Amendment 3

Solicitation Number 25-01

Temporary School Facilities for Colegio Ponceño

A-100

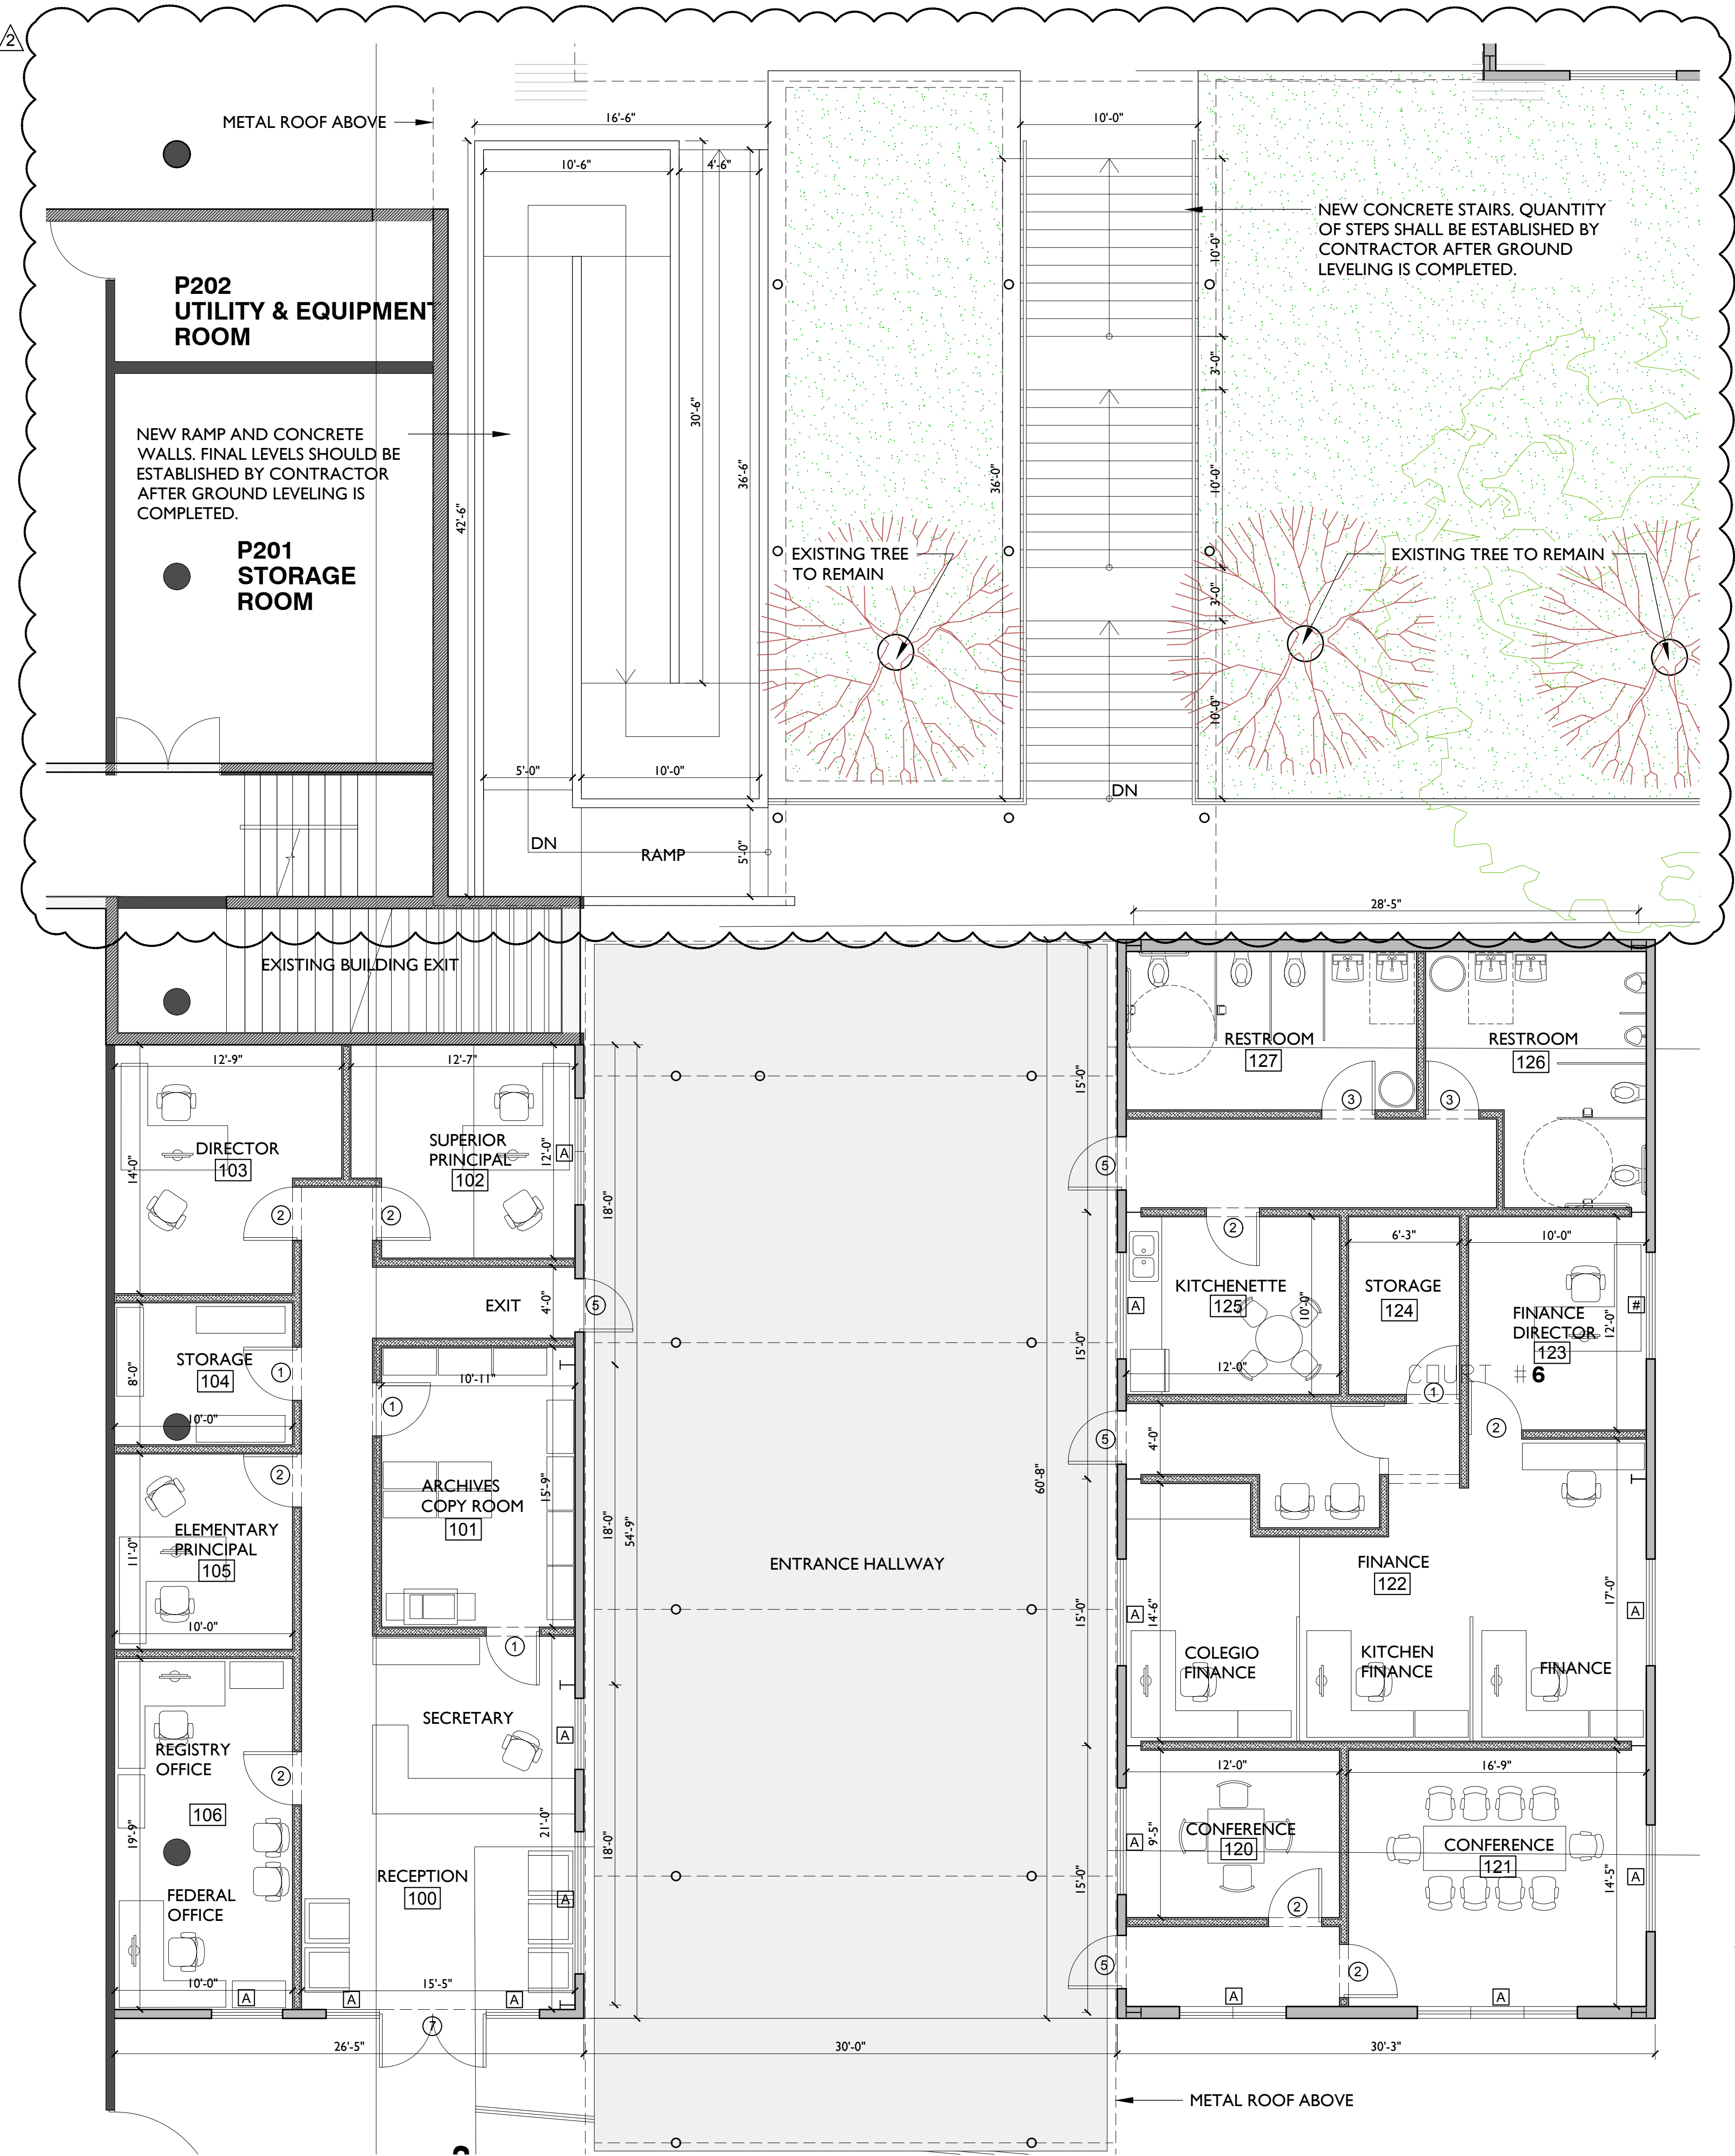
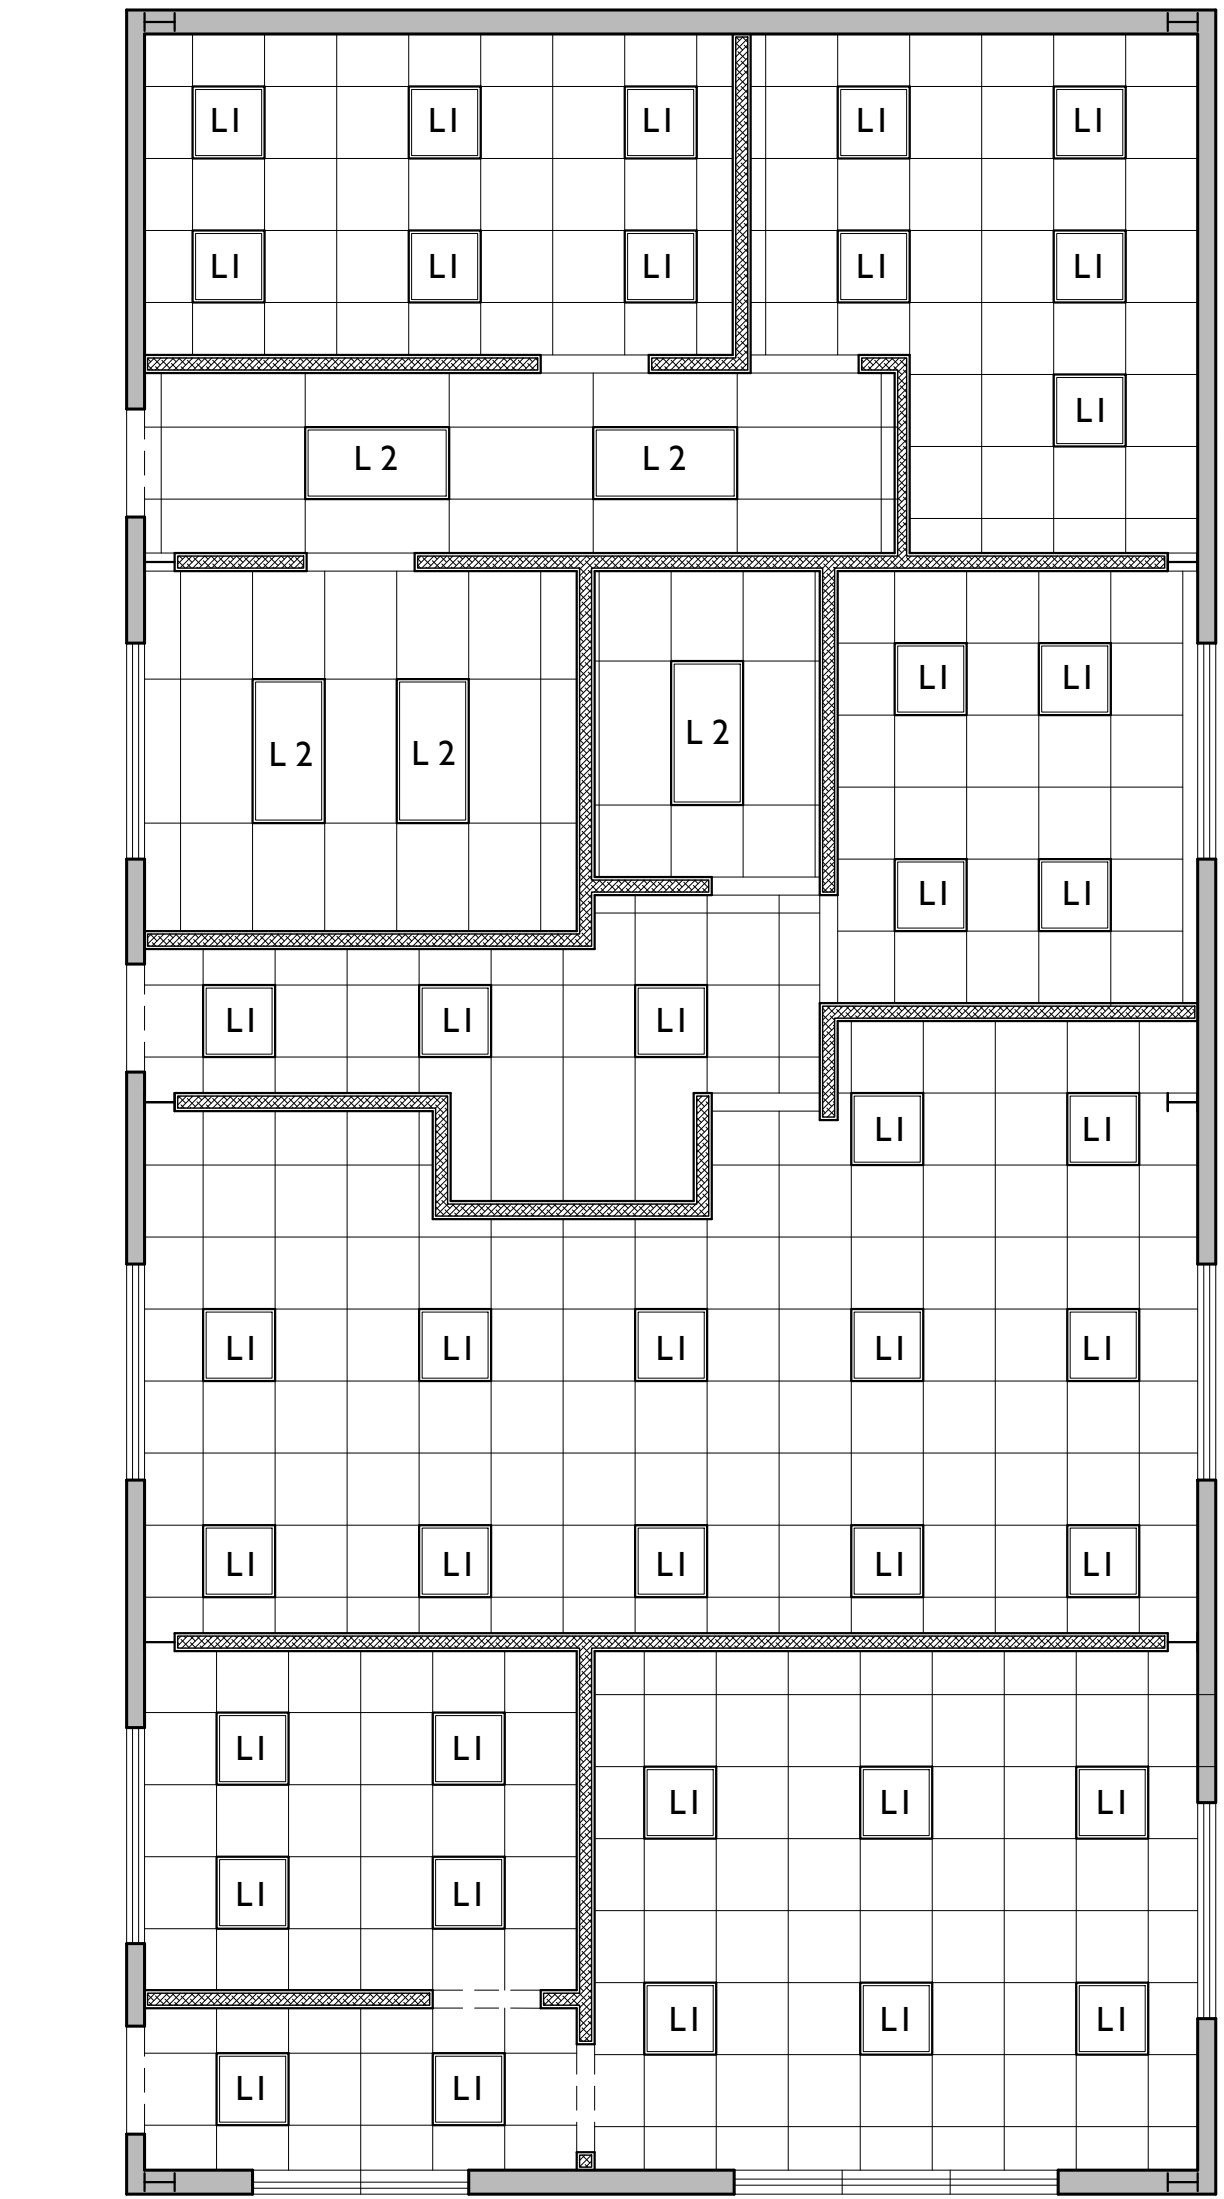
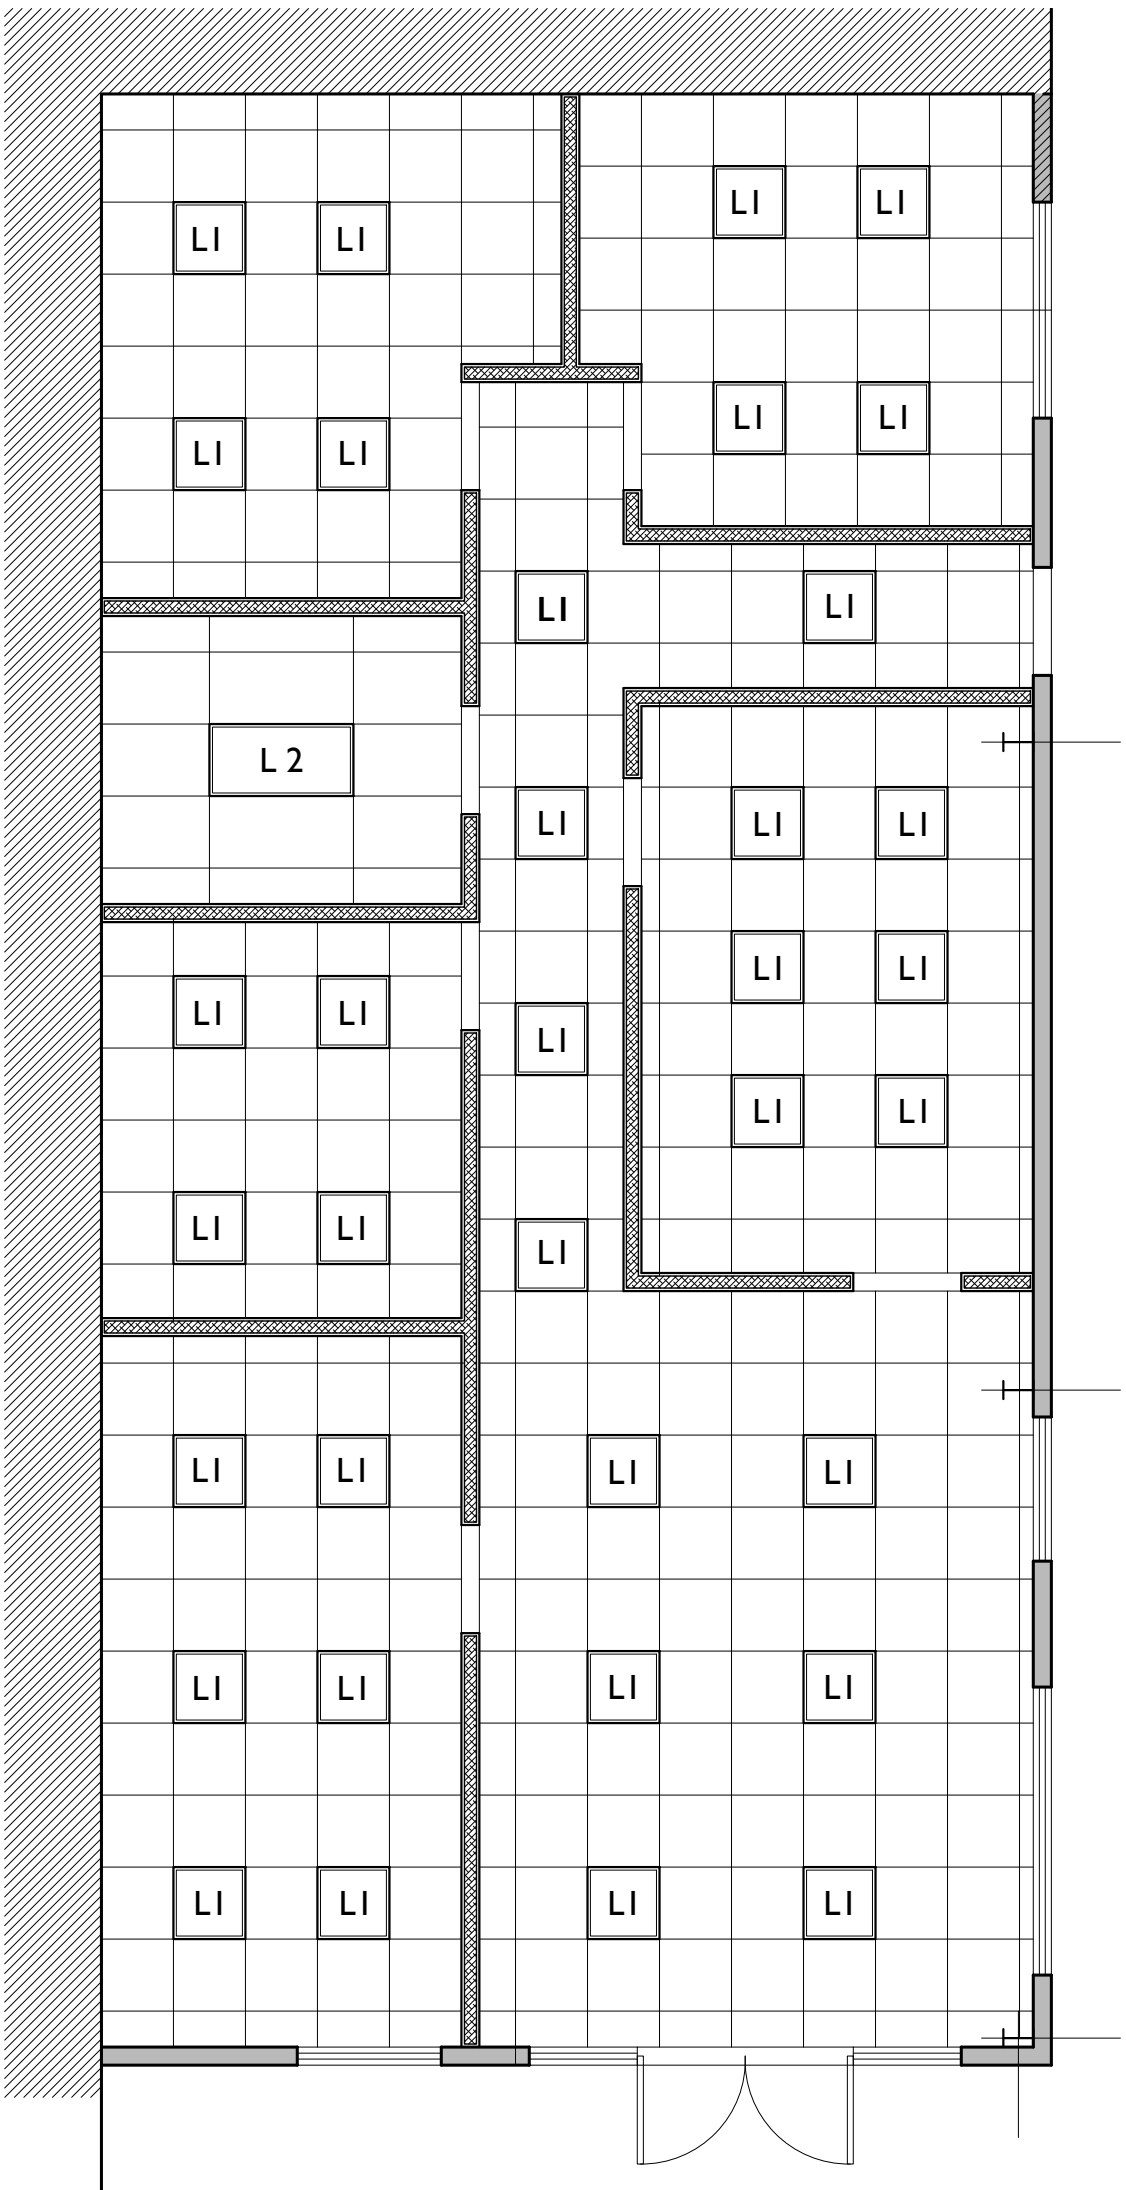
10.1.Door #3
 11. Swing door to access room 407 in the high school student bathrooms
11.1.Door #3
 12. Swing door in the waiting room of room 120 (Finance)

12.1.Door #2
2. Please clarify the window types in the following areas:
 - 2.1.Kitchen 214 facing the mechanical patio
2.1.1.Window type B
 - 2.2.Office 217 of the Cafetorium facing kitchen 214
